Access Compliance Report

Public Rights-of-Way

(Curb Ramps)

Intersection ID: 46492	Main Street: SHOPTON_RD_WEST	Cross Street: CASTLECOVE_RD	Location: S
ADA ID: FB0E40B77B7E	Ramp Type: PerpDiag	Initial Pass/Fail: Fail	Overall Compliance: No
Severity Score: 22.5			
Codes/Mitigation Info/Possible Solution		Field Measurements/Component Compliance

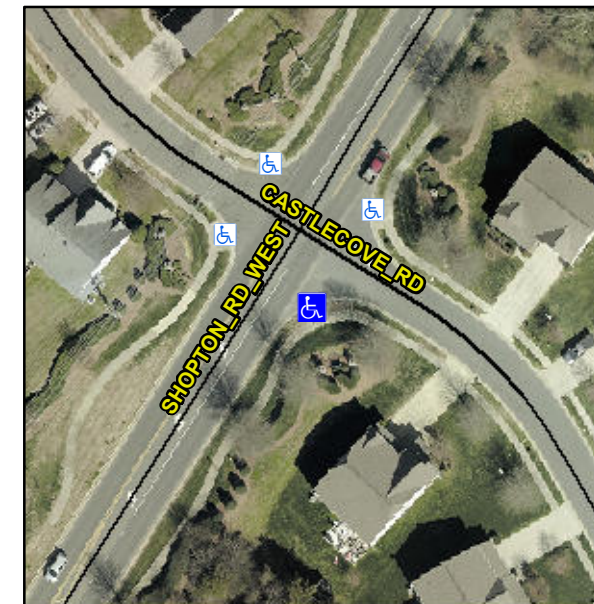
Not Found, R304.5.1, R304.2.2, R304.5.3

Compliance	Description	Data	Compliance	Description	Data
N/A	Ramp Length (in)	60.0	No	Ramp Slope (%)	8.7
No	Ramp Width (in)	46.5	No	Ramp XSlope (%)	4.7
N/A	Flare Type LT	N/A	N/A	Flare Type RT	N/A
N/A	Flare Slope LT (%)	N/A	N/A	Flare Slope RT (%)	N/A
N/A	Flare Traversable LT?	N/A	N/A	Flare Traversable RT?	N/A
N/A	Landing Length (in)	N/A	N/A	DWS Provided?	N/A
N/A	Landing Width (in)	N/A	N/A	DWS Contrast?	N/A
N/A	Landing Slope (%)	N/A	N/A	DWS Length (in)	N/A
N/A	Landing X Slope (%)	N/A	N/A	DWS Full Width?	N/A
N/A	Landing Curb? (Y/N)	N/A	N/A	DWS Offset (in)	N/A
N/A	Shared Landing?	N/A			
N/A	Gutter Ponding?	N/A	N/A	Gutter Slope (%)	N/A
N/A	Gutter Lip Ht (in)	N/A	N/A	Gutter X Slope (%)	N/A
N/A	Painted X Walk1?	No	N/A	Painted X Walk2?	No
	X Walk 1 Direction	To NE		X Walk 2 Direction	To NW
N/A	X Walk 1 Width (in)	N/A	N/A	X Walk 2 Width (in)	N/A
	X Walk 1 Slope (%)	0.5		X Walk 2 Slope (%)	1.0
	X Walk 1 X Slope (%)	2.0		X Walk 2 X Slope (%)	0.4

Remove & Replace Curb Ramp With Two New Directional Ramps or Equivalent.
